**SUNDRY NOTICES AND REPORTS ON WELLS**  
*Do not use this form for proposals to drill or to re-enter an abandoned well. Use Form 3160-3 (APD) for such proposals.*

### OPOASU #5

Mewbourne Oil Company  
NM-9218: QPQASU #5  
API: 30-025-25620  
Lea County, New Mexico

RE: Plugging and Abandonment Procedure -- Conditions of Approval

**QPQASU #5**  
 Last Updated: 4/8/10  
 By: R Terrell

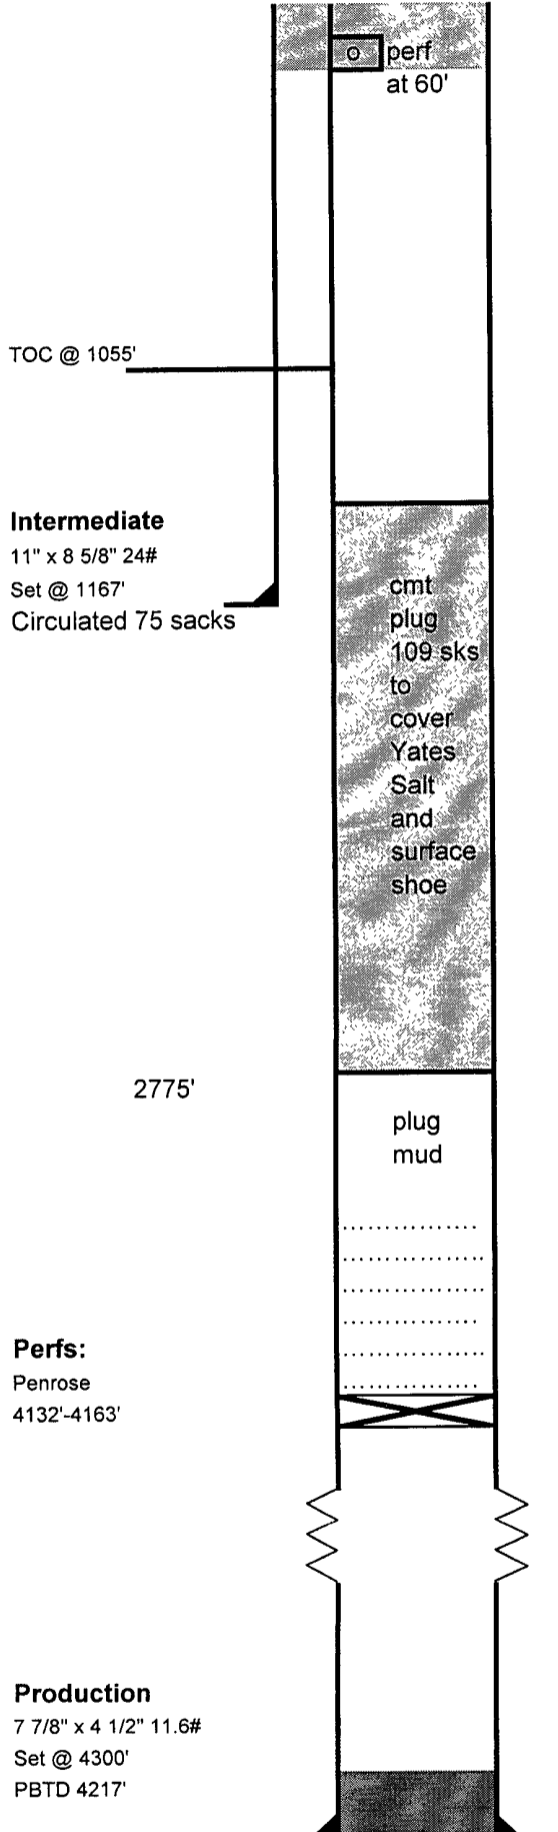
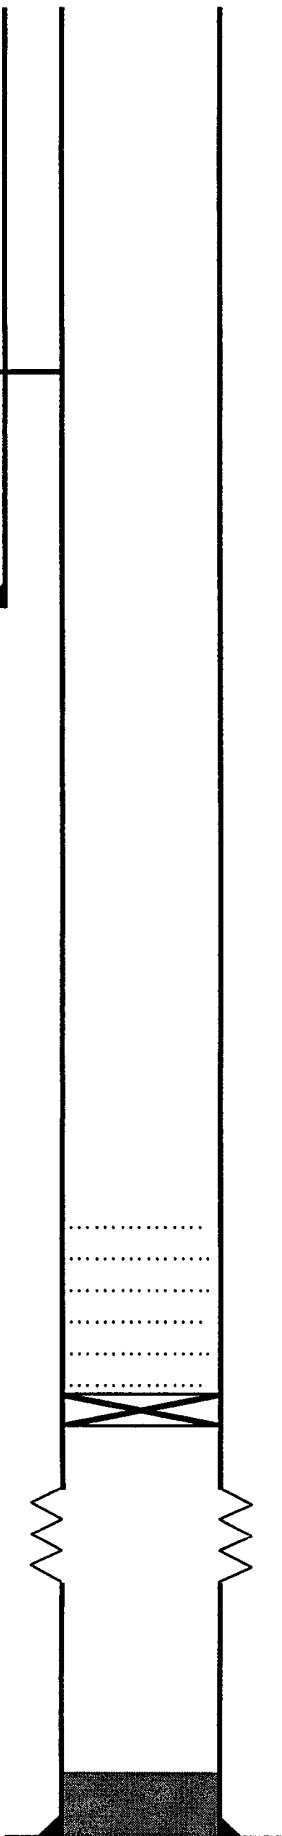
1. OK
  2. OK
  3. OK
  4. OK
  5. OK (Yates – Salt – Casing shoe)
  6. Tag at 1117' or shallower – Otherwise OK
  7. OK
  8. OK
  9. OK
  10. OK (Surface)
  11. Verify cement to surface in all annuluses. Ground Level Dry Hole Marker required in this area – Requirements attached.
  12. Submit subsequent report, with details.
-
